Notice of Request for More Information Response Document

Site name: Hemerdon Mine Mineral Processing Facility
Site address: Hemerdon Mine, Plympton, Devon PL7 5BS
Operator name: Drakelands Restoration Limited
Application reference: EPR/AP3203ML/A001

Document Ref: SPC0124/Schedule5 Response/TWL October 2023

Figure 1 – Far field measurements for the chute scenario for 10-50Hz

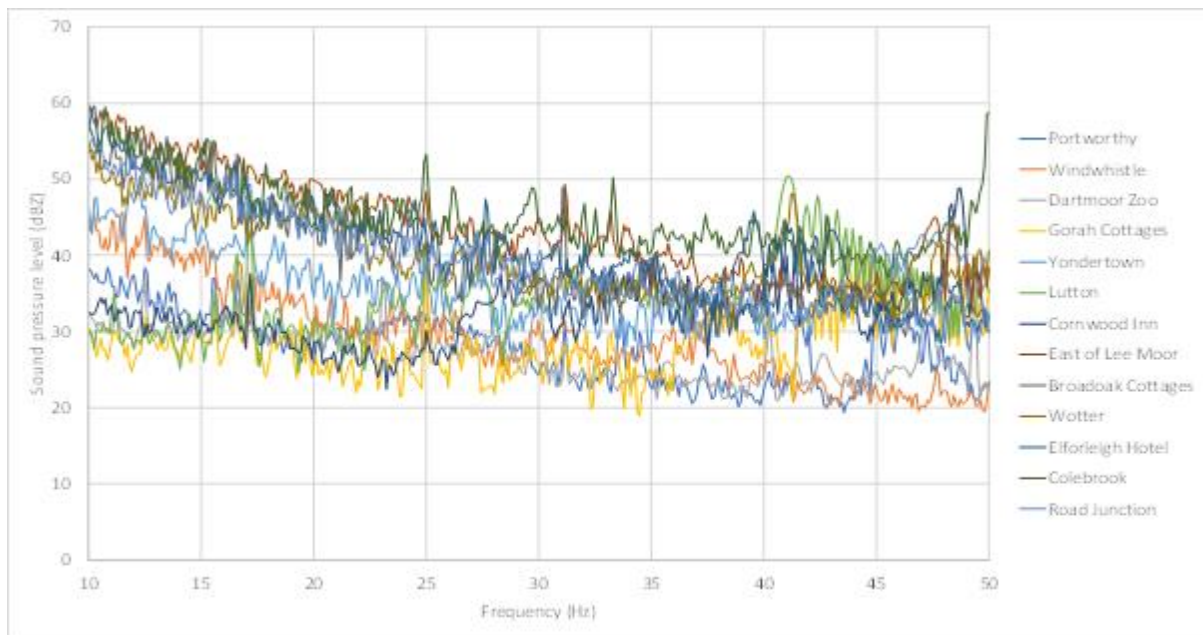
Provide an explanation of why the enclosure appears to have resulted in an increase in near field sound pressure levels at the second harmonic frequency 25 Hz in multiple test scenarios, including (marginally) the scenario with outlet chute (section 5.3.18 and Figure 5-17). What results were obtained for measurements in the far field at this frequency? Provide an explanation of any impact this has on uncertainty of conclusions. What results were obtained for sound pressure levels at the third harmonic 37.5 Hz? Provide an appropriate explanation of these results.

The spectra for the range up to the second harmonic for all the far field measurements with the chute in place are shown in Figure 1 below. There is little evidence that the second harmonic makes a significant contribution, but the first harmonic is contributing. The highest level was measured at Colebrook with a value of 53.3 dBZ. This frequency is just inside the audible range, although the weighted level is low (8.6 dBA). When the spectrum at Colebrook is examined over a wider frequency range, it becomes apparent that there was a strong source at 50 Hz. This had harmonics at 50 Hz with a sub-harmonic at 25 Hz. It is therefore probable that the contribution from the screen at 25 Hz was much lower than the measured value. The monitoring location at Colebrook was in an industrial estate with machinery operating all around, so this result was not surprising.

Figure 3 – Extract from NIA showing Tested Distributed Vent Locations

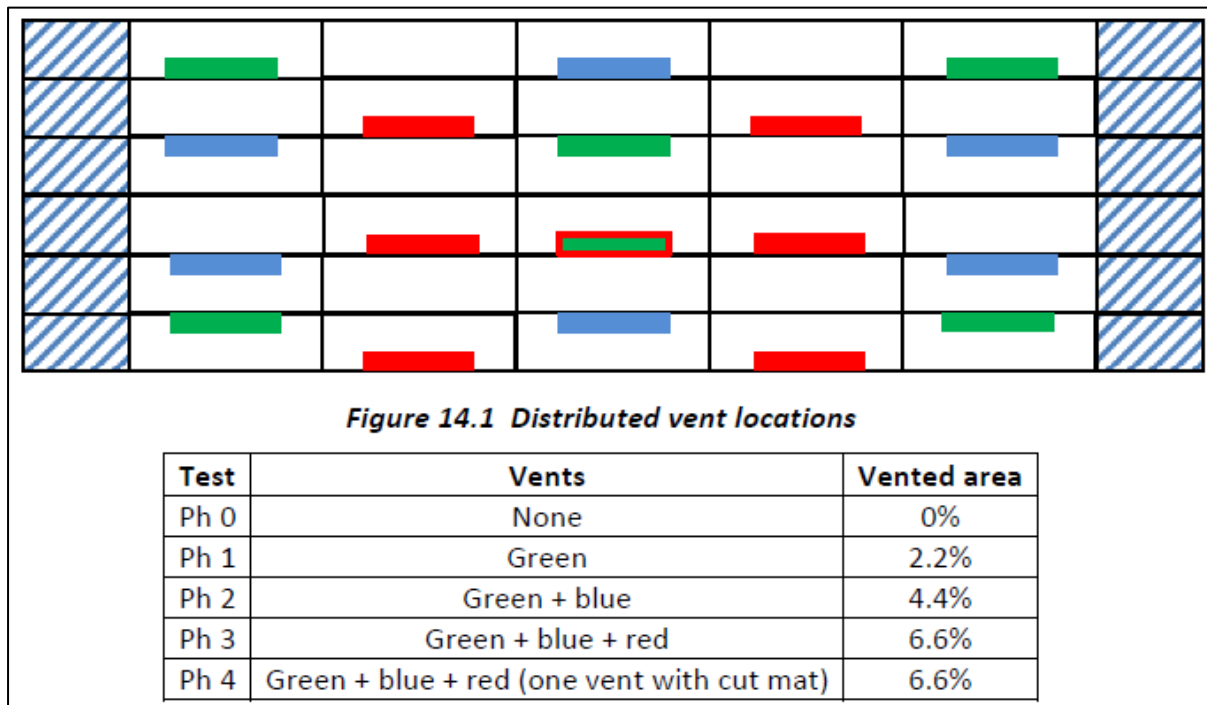
Provide justification for the 6 dB reduction by deck venting.

Attenuation expected from deck venting is explained in Appendix O of the NIA. This contains the results from a series of trials with the objective of working out the best arrangement for venting a deck surface. As the trial progressed, it became clear that distributed venting gave the best performance, although any deck venting was a benefit.

The final set of tests explored distributed venting in a screen deck initially covered in plywood. The base case was with no openings in the plywood and then a series of tests were carried out, increasing the vented area up to 6.6%. The arrangement is shown in the Figure 3 below:

These results show that over 12 dB attenuation was achieved in the far field if the vented area could be distributed and 6.6% of the total deck area.

The claim that deck venting could provide 6 dB attenuation is being cautious.

Typical Chute Configuration - Screen To Undersize Wet Transfer Hopper

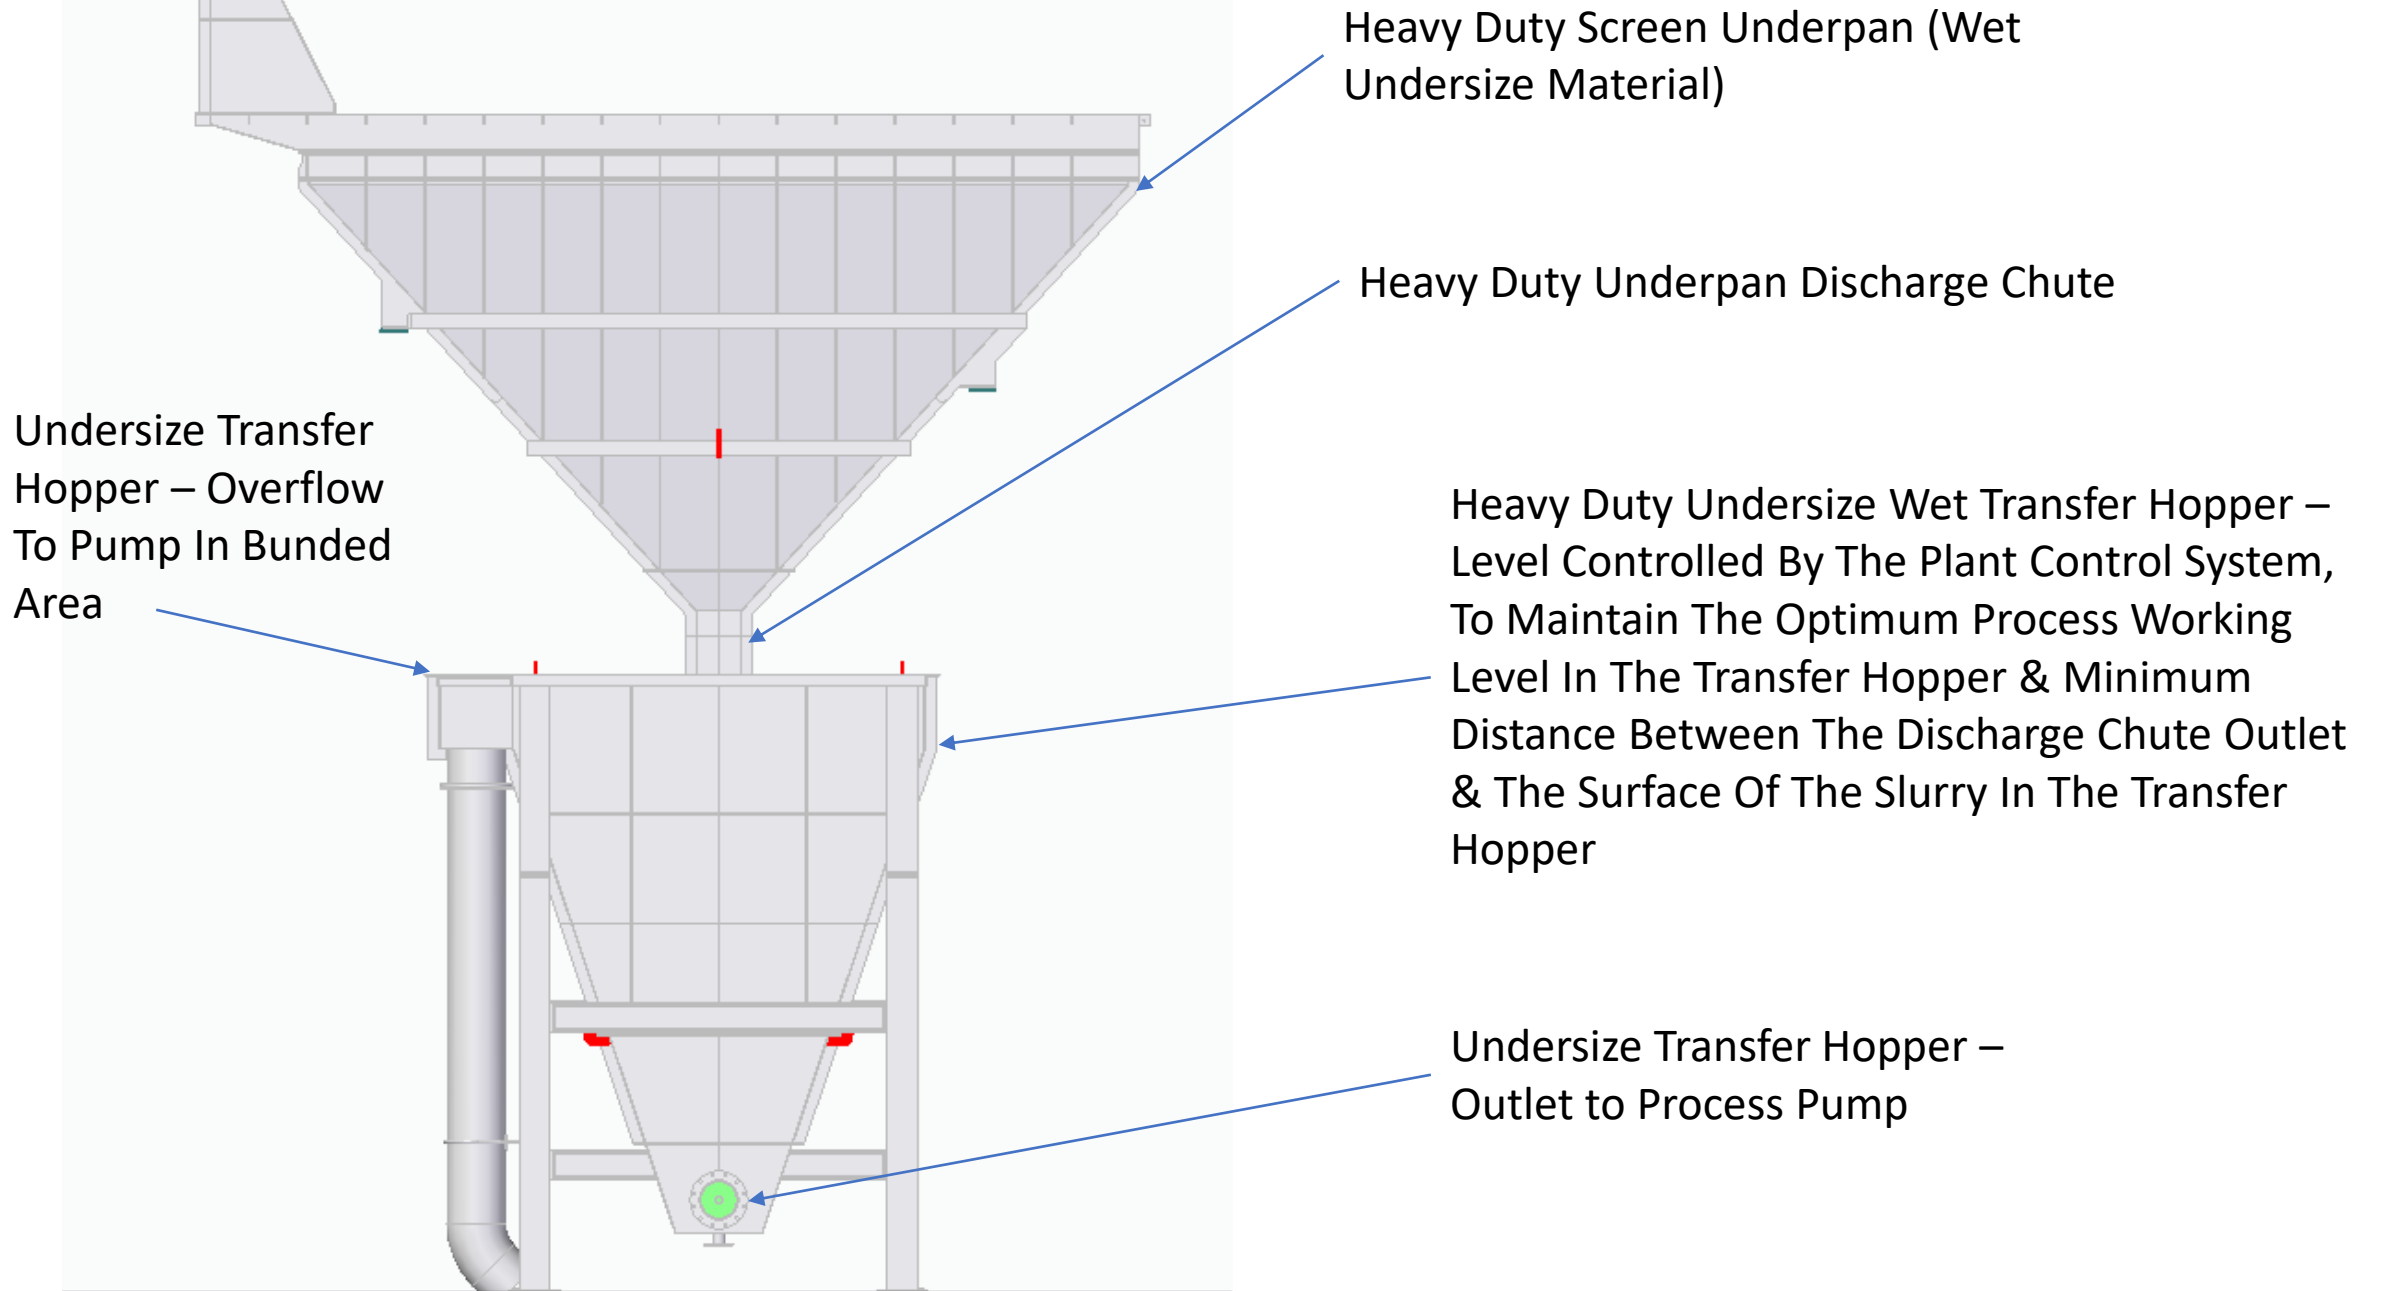
Provide an explanation of how the chute design that has been tested, would be replicated on site for all relevant screens.

It is unclear that the chute design, as tested, could be practically replicated for all screens. This would include the distance between the end of the chute to a solid surface or processed material, and the dimensions of any open area at the end of the chute. If this scenario could not be replicated then there is concern that the estimated 6 dB additional reduction could not be achieved.

had been reduced to 1.2 m² by the final test that included the chute. The actual chute design will ensure that the LFN emissions will be no greater than those measured during the trial. Appendix B shows the various possible configurations of chutes that are proposed.

Estimating the screen contribution from background levels

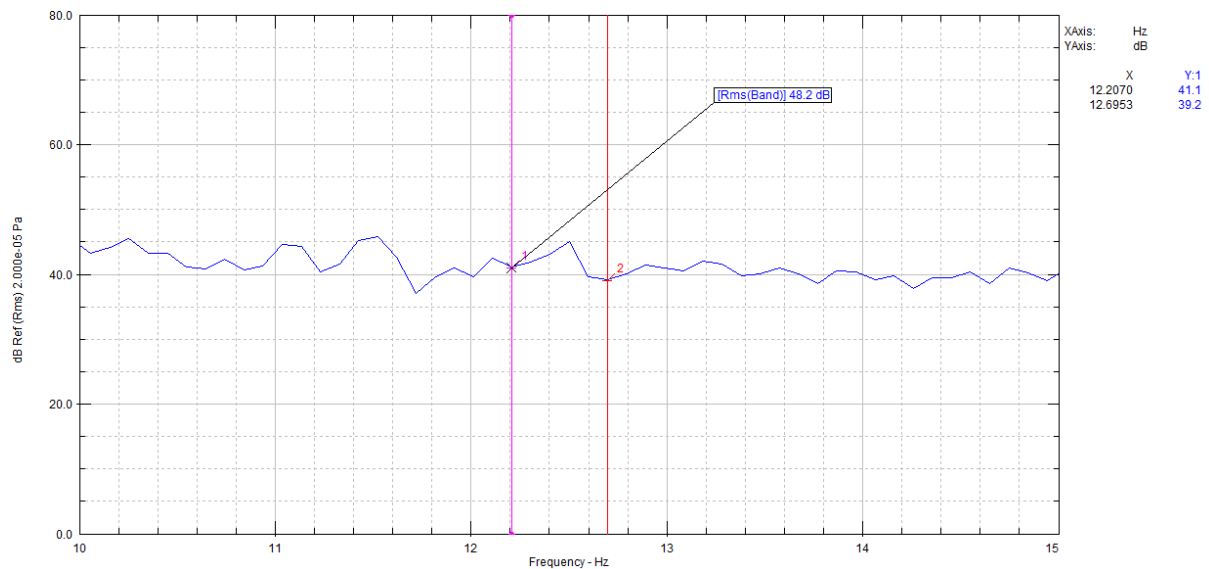
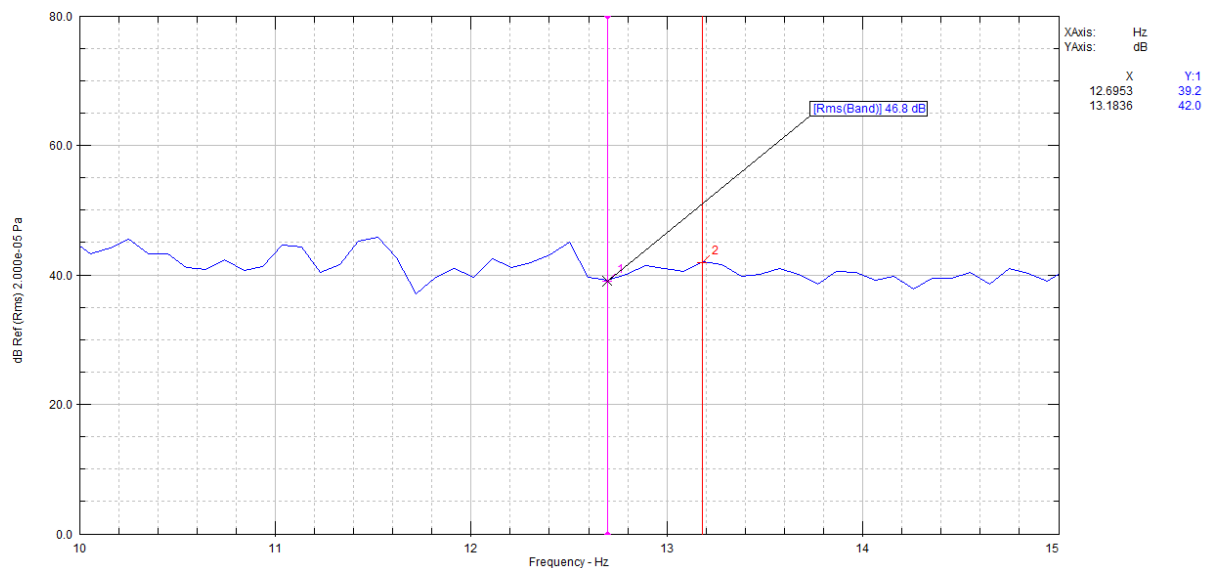
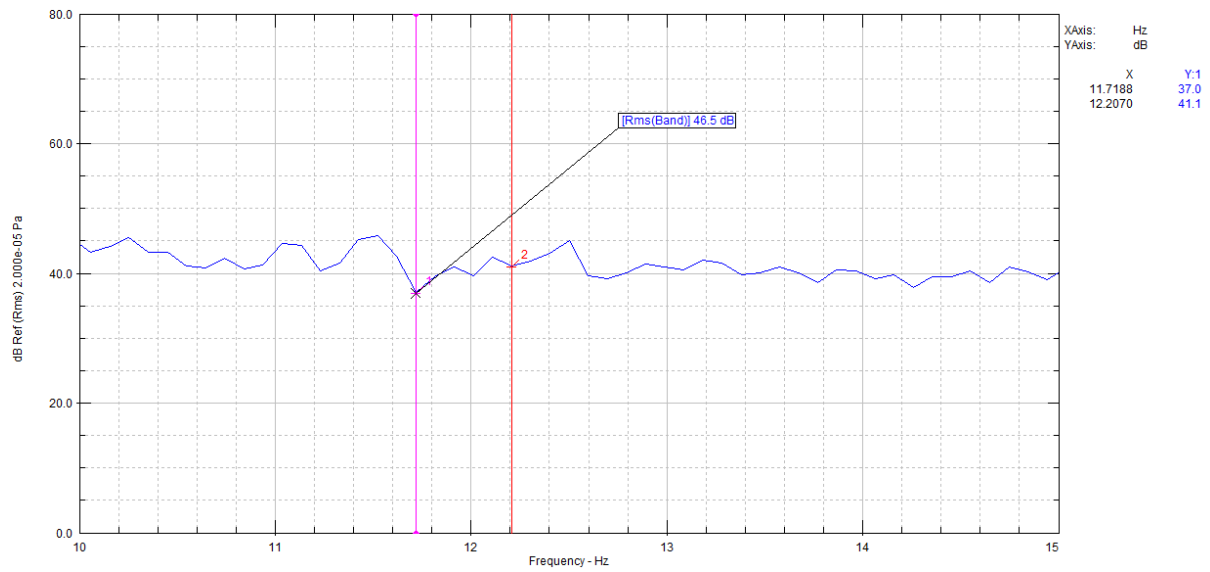
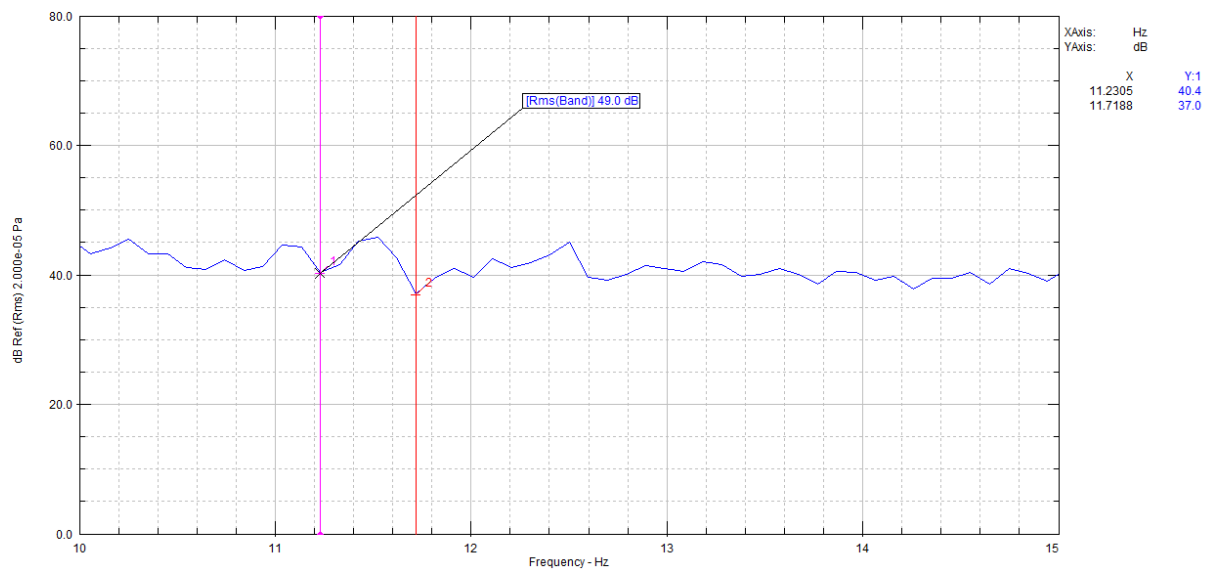
Provide an explanation of why the enclosure appears to have resulted in an increase in far field sound pressure levels at the fundamental frequency 12.5 Hz in multiple test scenarios (Table 5-3) and any impact this has on the uncertainty of conclusions.

Consider the same width band immediately adjacent on the higher frequency side. This has a level of 46.8 dBZ. If the assumption was made that the background level in these two bands was the same, the screen must be contributing the difference, which is 42.6 dBZ.

Taking the adjacent band on the lower frequency side, the level is 46.5 dBZ, and this would mean the contribution from the screen would be 43.3 dBZ

Taking the next band down, the background level is 49.0 dBZ. Using the same methodology to separate the background from the screen would imply that the screen is **removing** 41.3 dBZ from the environment, which is clearly impossible.

This illustrates the problems of estimating the contribution of a source when it is so close to the background level.
